## NOTICE OF APPROVAL

**Planning Case #:** Design Study 24215

**Project:** DS 24215 (Yang-Bauer)

**DS 24215 (Yang-Bauer)** authorizes amendments to previously approved Design Study Applications (DS 21-362 (California Coast, LLC)) located at San Carlos 2 SW of 1<sup>st</sup> Avenue in the Single-Family (R-1) District. APN: 010-126-017-000

**24 PROPOSED ROOF PLAN**  
 3/16" = 1'-0"

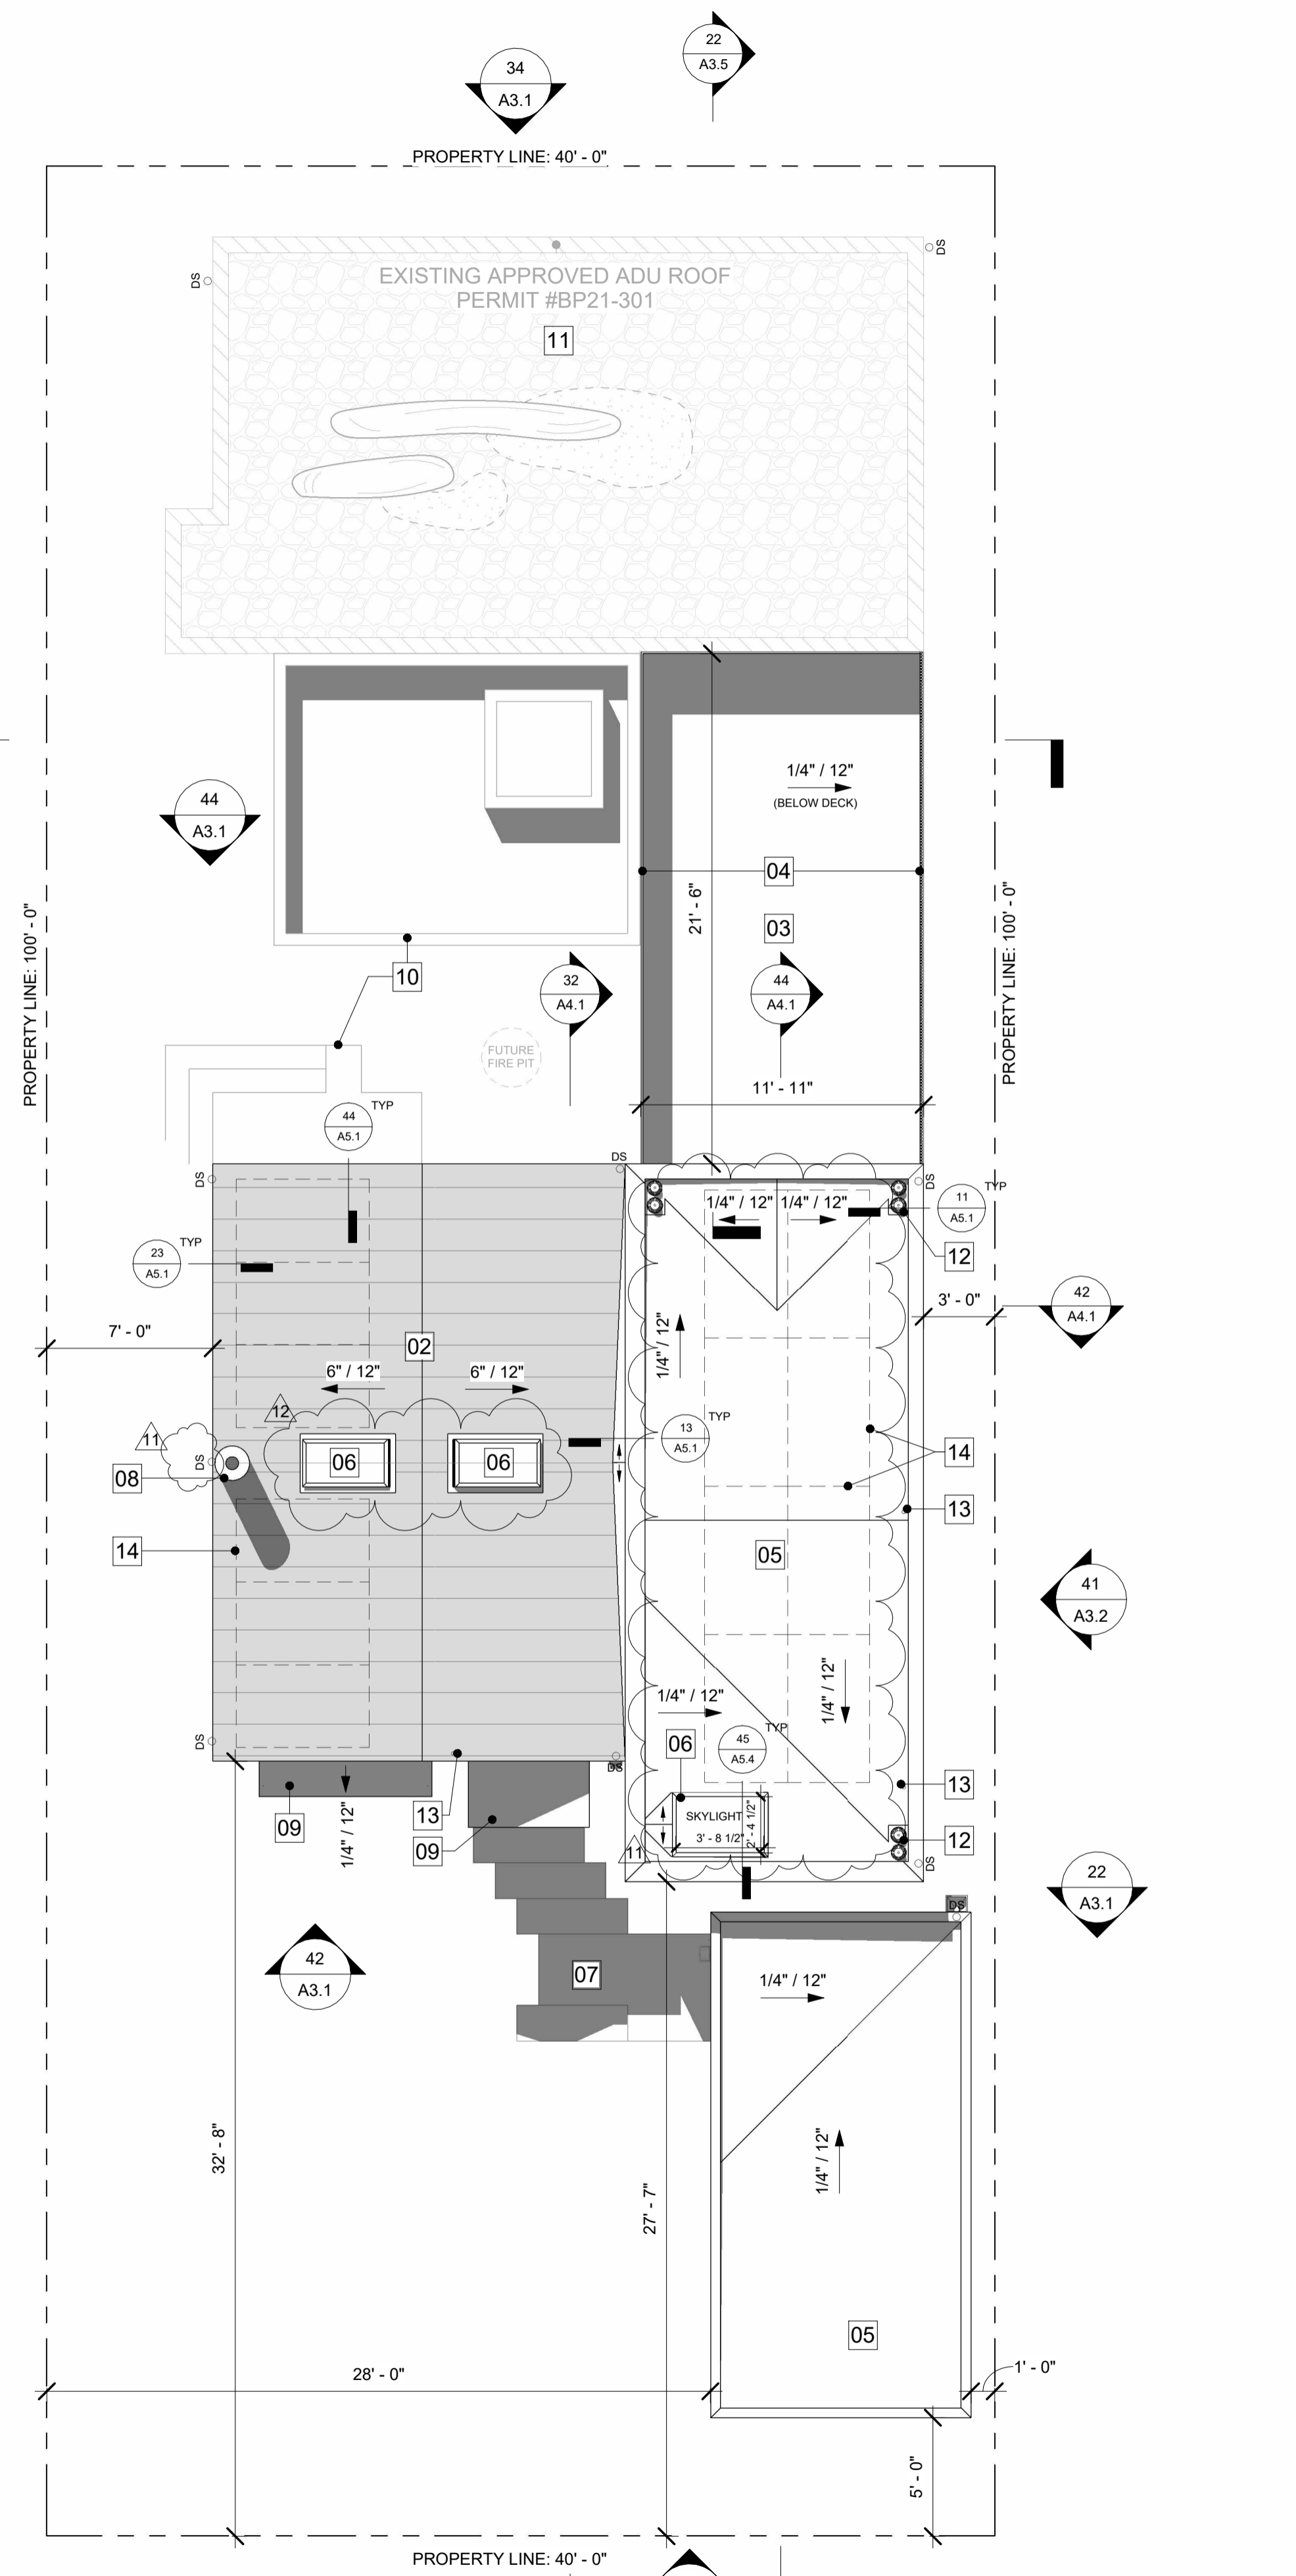
- The installation of two skylights and horizontal 10” Hardie siding painted to match the previous wood siding. The previously approved project proposed vertical wood siding and did not include the proposed skylight.

3. Are consistent with applicable adopted design review guidelines.	✓	
<b>Additional Staff Analysis/Discussion:</b>		
The applicant has updated the plans from after the previous approval, relocating the skylights to be less visible from the street.
